Technical Service Bulletin: TSB200118

ReCon® Cylinder Head Mounting Hole Salvaging

Figure 1, Acceptable Recon® Cylinder Head Mounting Hole Salvaging

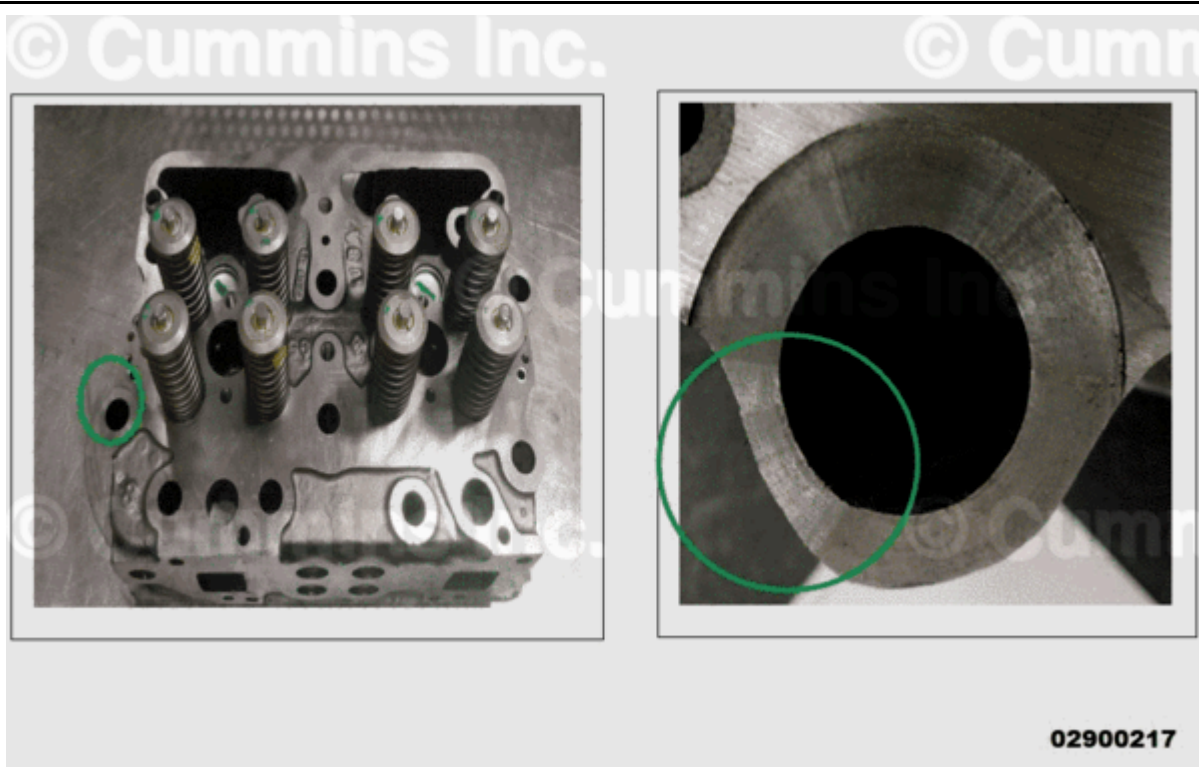
- This document is to inform field that ReCon® cylinder heads produced and sold using machining processes may look different, but have the same fit, form, and function. Reference Figure 1 below.
- ReCon® cylinder heads can have waviness or chattering marks observed on mounting hole face after spot machining operation on the rocker lever face side.
- Spot machining is one of the multiple regular salvaging processes deployed during remanufacturing to remove the step marks at that location after dismantling.
- After spot facing of mounting holes, waviness or chattering marks is predominantly observable in cylinder heads which have undergone welding salvage at mounting hole compared to the ones which did **not** need the welding salvage.
